OF
FREEMAN LOGISTICS

| 5 | 12/13/24 | DTC | JSM | JSM | SEPA RESUBMITTAL |

EXISTING CONDITIONS
FOR
FREEMAN LOGISTICS

Job Number: 21585
Sheet: C21 of 44

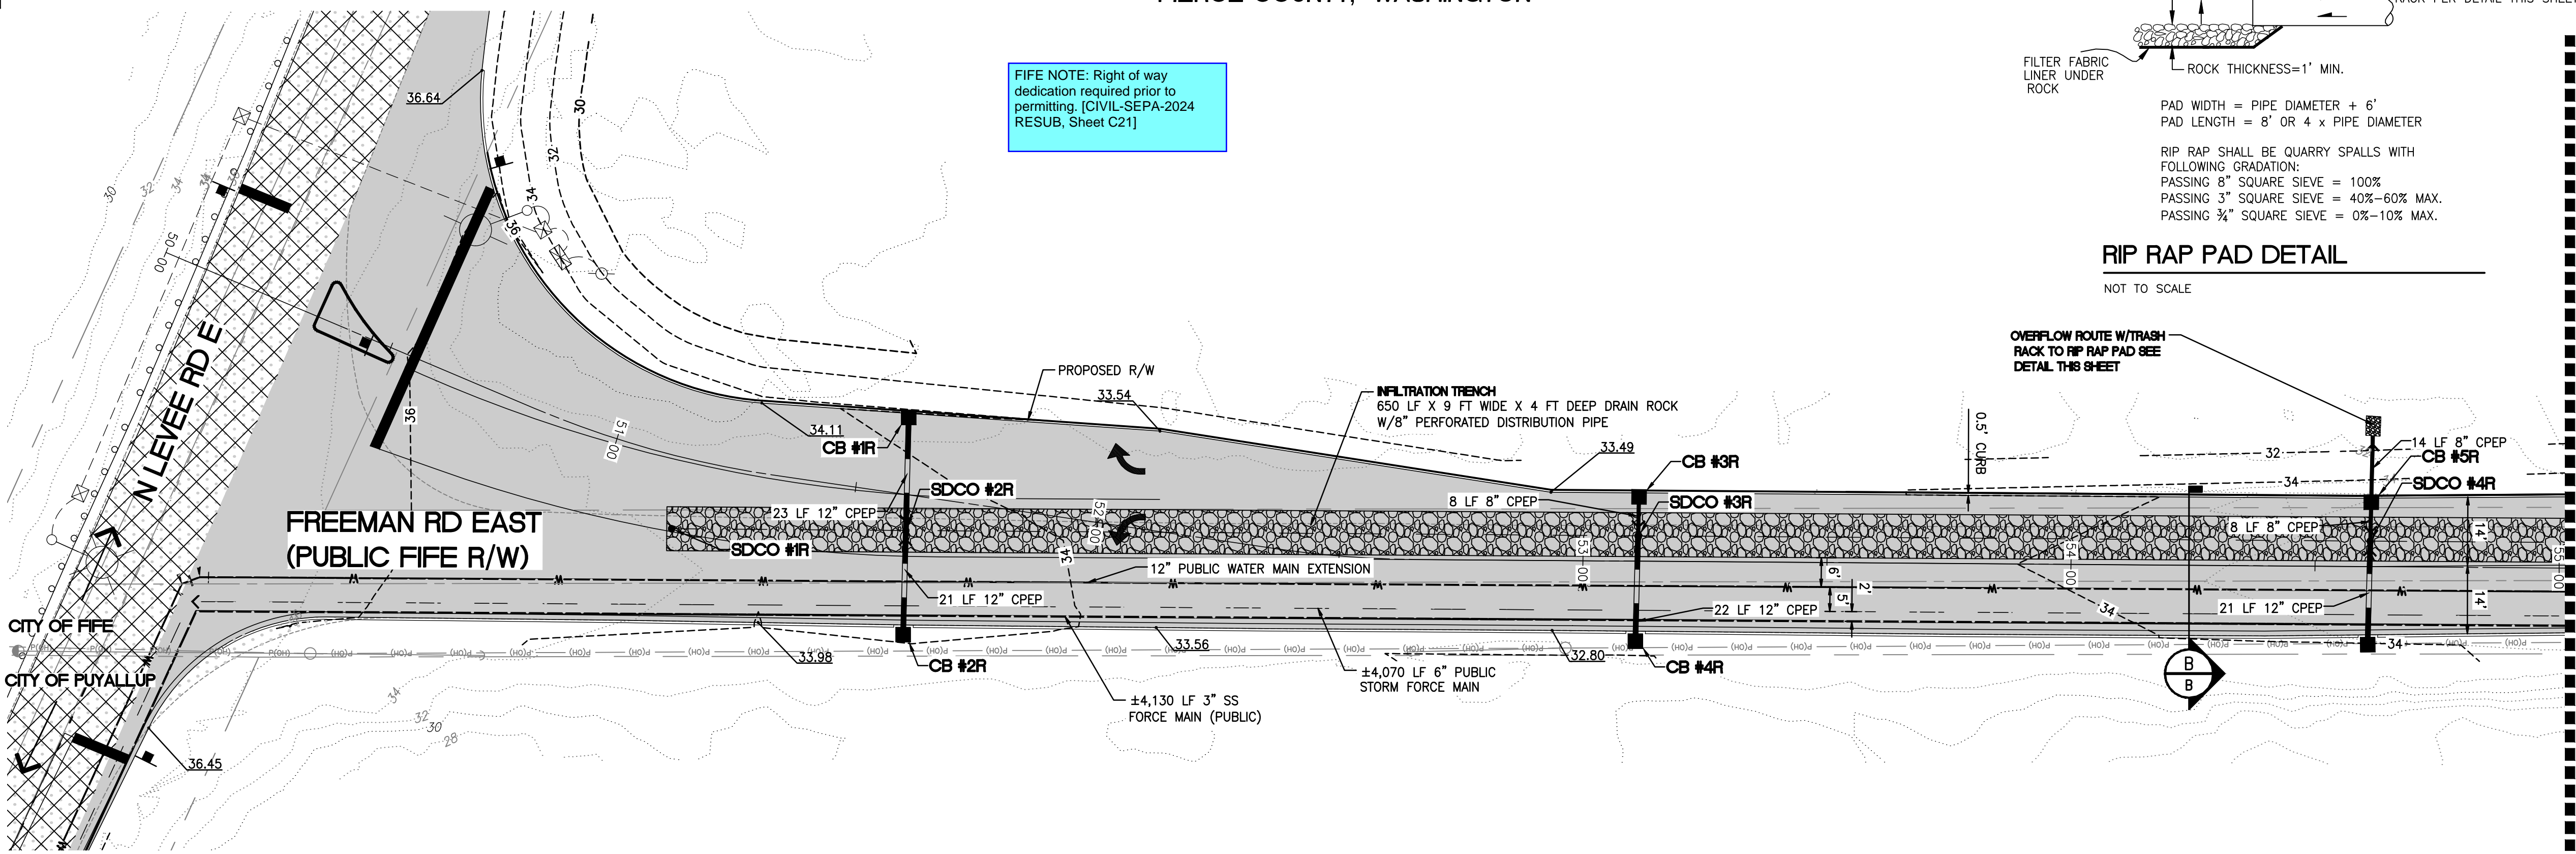
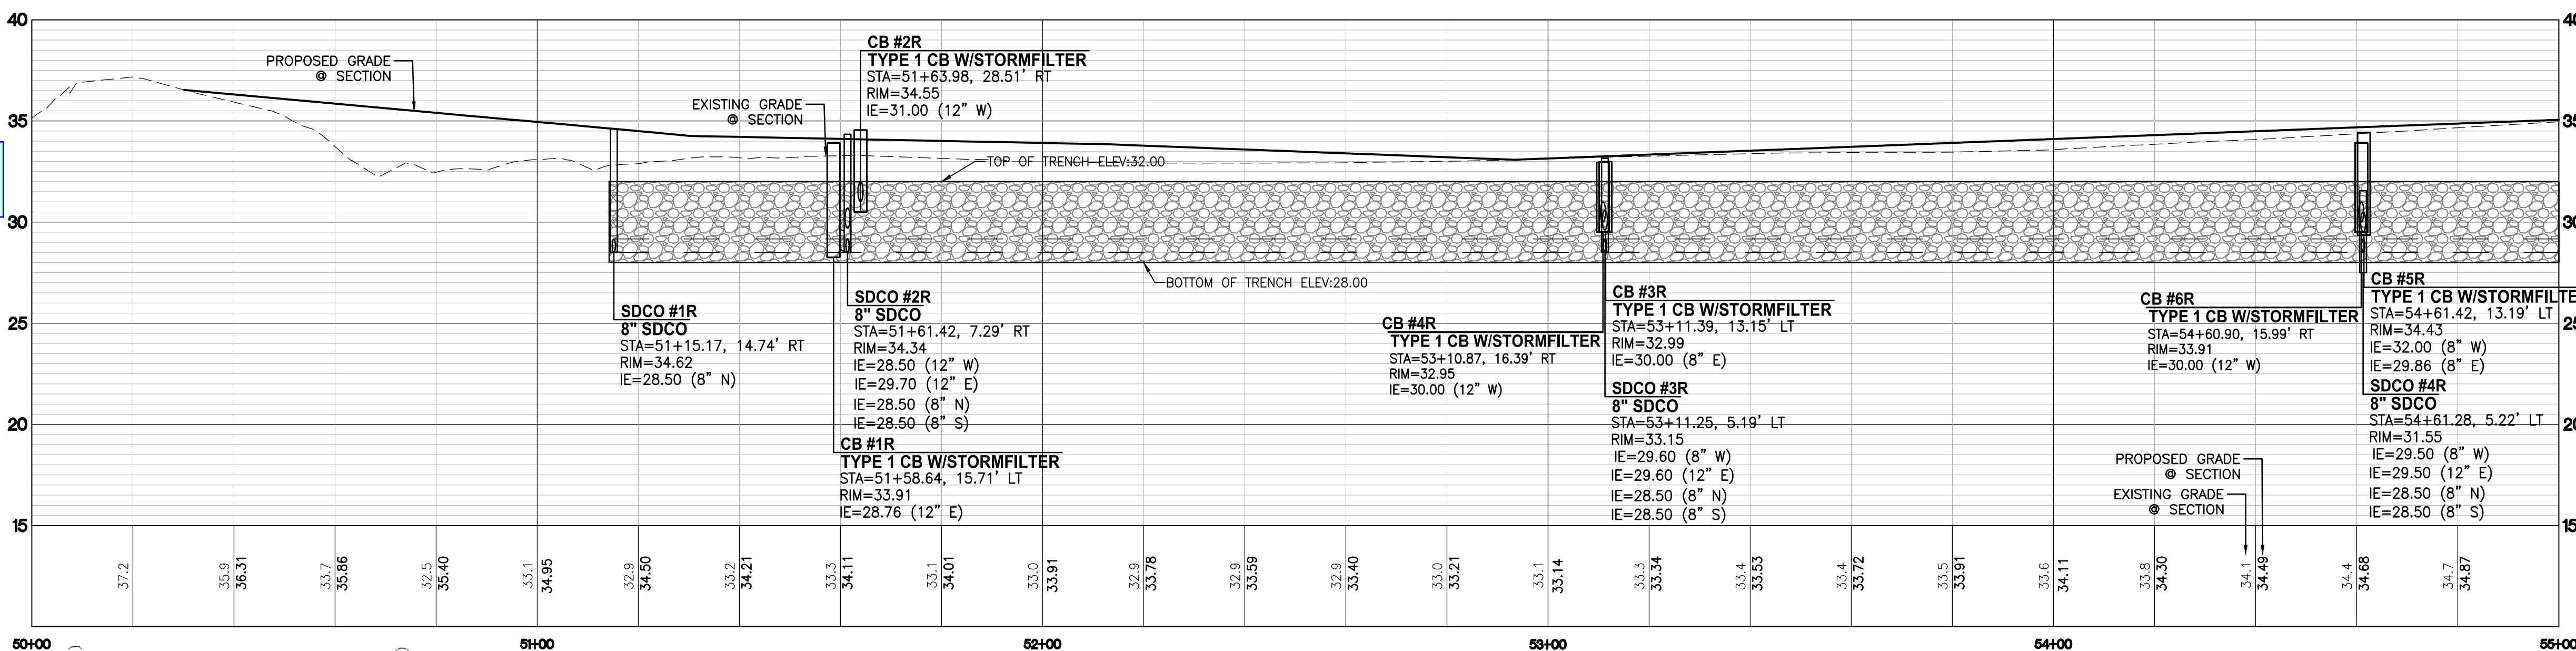
FIFE NOTE: Right of way dedication required prior to permitting. [CIVIL-SEPA-2024 RESUB, Sheet C21]

FIFE NOTE: Show seasonal groundwater elevations in relation to proposed infiltration trench elevations. [CIVIL-SEPA-2024 RESUB, Sheet C21]

FIFE COMMENT: Enhance cross section and clearly illustrate how future Fife utilities (sewer and water) will have adequate space for standard installation. Also show all existing and proposed crossings in profile. [CIVIL-SEPA-2024 RESUB, Sheet C21]
